Watts Bar Nuclear Plant, Units 1 and 2
Facility Operating License Nos. NFP-90 and NFP-96
NRC Docket Nos. 50-390 and 50-391

Subject: Response to NRC Request for Additional Information Regarding Application to Implement the FULL SPECTRUM™¹ LOCA (FSLOCA™¹) Methodology for Loss-of-Coolant Accident (LOCA) Analysis and New LOCA-specific Tritium Producing Burnable Absorber Rod Stress Analysis Methodology (WBN-TS-19-04) (EPID L-2020-LLA-0005)

Response to NRC Additional Request for Additional Information (Non-Proprietary)

Figure 6: TPBAR LBLOCA response from Tritium Production Core Topical Report (Figure 2.15.5-1 of the TPC Report)

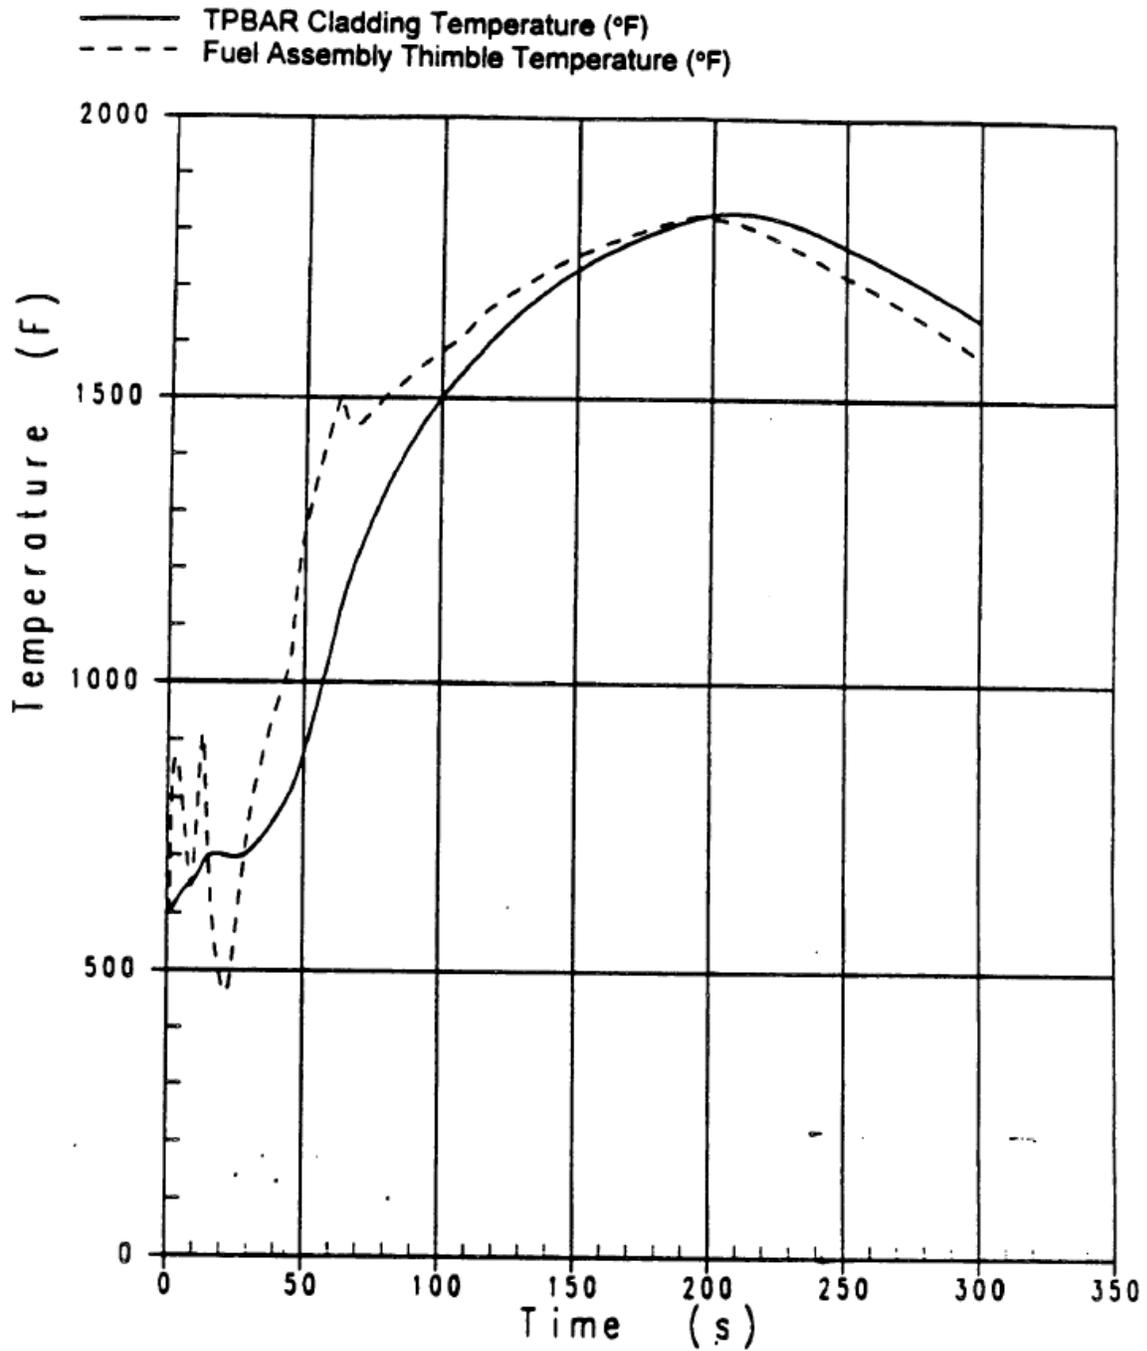
*(b) [] []
Provide justification for this assumption.*

*(c) TVA states that the TPBAR figure-of-merit (for rapid burst failure mode and thermal creep rupture node) calculation is performed [] []
Provide the rationale for this assumption.*

Simulations with a modified version of the LOCTA_JR fuel rod response code were performed with Appendix K LBLOCA boundary conditions, with results for the TPBAR as replicated in Figure 6 (Figure 2.15.5-1 of Reference 2). As described in Section 2.15.5.1 of Reference 2, LOCTA_JR uses the cladding temperature of the surrounding fuel rods and the core steam and entrained liquid convective heat transfer coefficients and temperatures as boundary conditions for the calculation of the TPBAR response within the fuel assembly guide thimble. Use of the LOCTA_JR code for TPBAR modeling in the TPC was approved by the NRC in Reference 4.

As shown in Figure 6, the fuel assembly thimble temperature leads the TPBAR cladding temperature with respect to time. In periods of heating, the thimble temperature heats sooner and faster than the TPBAR, and in periods of cooling, the thimble temperature cools sooner and faster. In the refill and late reflood phase of the transient (up to 200 seconds in Figure 6), when temperatures are increasing, the TPBAR cladding temperature will follow the thimble temperature and tend to remain lower until after the temperature peak is reached.

Figure 2c-1: Simplified Diagram of Temperatures Seen During a LOCA

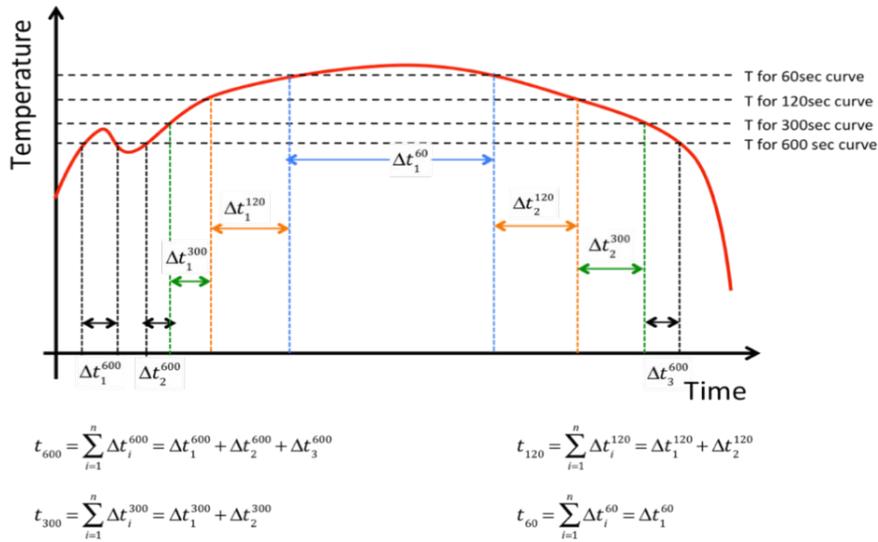
- (a) Describe the five sets of experimental bursts tests performed by Pacific Northwest National Laboratory (PNNL). Describe how these experiments simulate the TPBAR thermal creep rupture failure.*
- (b) Describe the details of the cladding burst rupture model used in the TPBAR failure analysis.*
- (c) Provide details of the cladding creep rupture model and the procedure to develop the time to rupture curves.*
- (d) Describe how the burst and creep burst curves are used to determine the TPBAR failure assessment. The response should include the criteria to determine cladding failure.*

Figure 2c-1 is a simplification to illustrate the approach used to implement the creep rupture model. In the case of actual LOCA conditions, the model considers the time variation of both the applied stress and temperature in the calculation of the life fraction.

Comparison of the discrete model shown above, and a continuous integration of the life fraction rule, finds that in certain conditions, the discrete model can under-predict the life fraction. To account for the potential for an under-prediction of the life fraction, a factor of 2 has been applied in the TPBAR stress analysis approach.
